Addendum 47 – UN Regulation No. 48

Revision 13 - Amendment 4

Supplement 3 to the 07 series of amendments – Date of entry into force: 4 January 2023

Uniform provisions concerning the approval of vehicles with regard to the installation of lighting and light-signalling devices

Annex 1, item 9.22., amend to read:

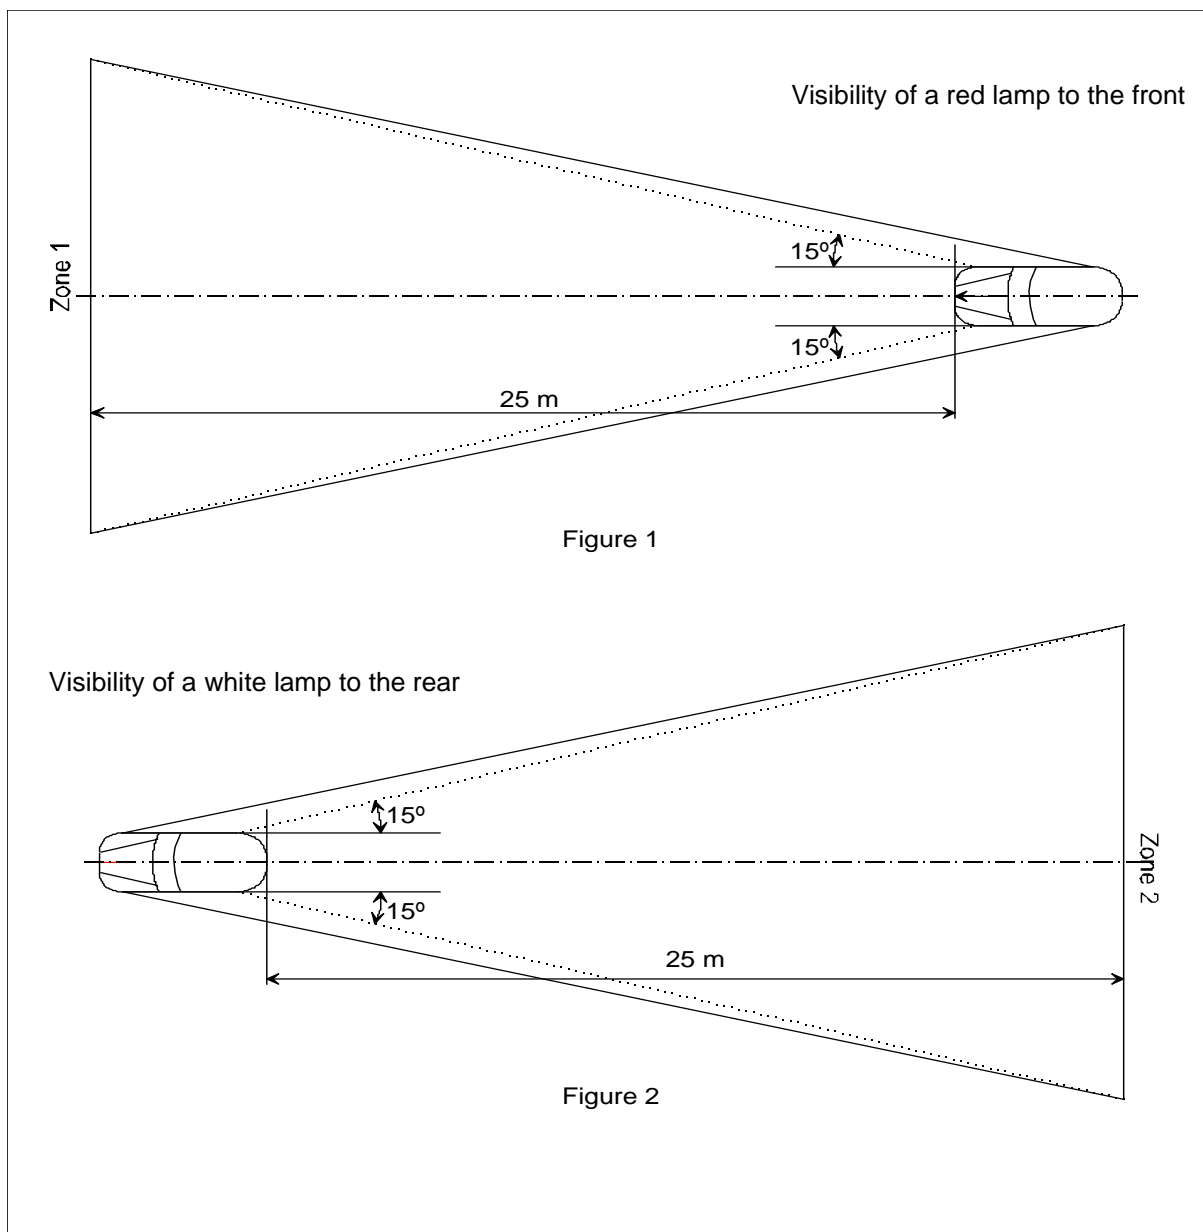
| "9.22. | Adaptive front lighting system (AFS): | yes/no ² |
| 9.22.1. | Main-beam ADB | yes/no ² |
| 9.22.1.1. | Main-beam ADB + Driver Assistance Projection | yes/no ² " |

Visibility of a red lamp to the front and visibility of a white lamp to the rear

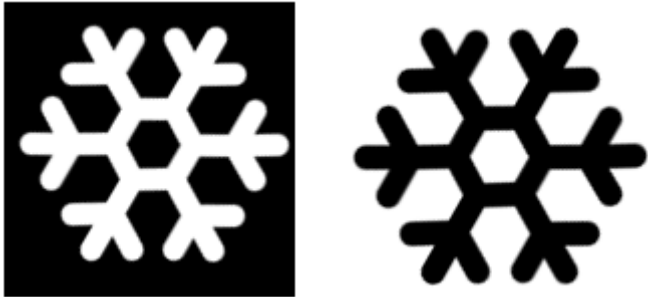
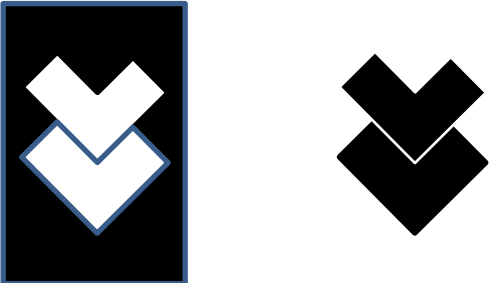
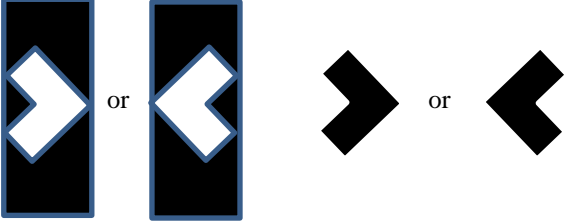
Annex 4, amend to read:

In their respective planes, the zones 1 and 2 explored by the eye of the observer are bounded:

- In height, by two horizontal planes 1 m and 2.2 m respectively above the ground;
- In width, by two vertical planes which, forming to the front and to the rear respectively an angle of 15° outwards from the vehicle's median longitudinal plane, pass through the point or points of contact of vertical planes parallel to the vehicle's median longitudinal plane delimiting the vehicle's overall width; if there are several points of contact, the foremost shall correspond to the forward plane and the rearmost to the rearward plane."
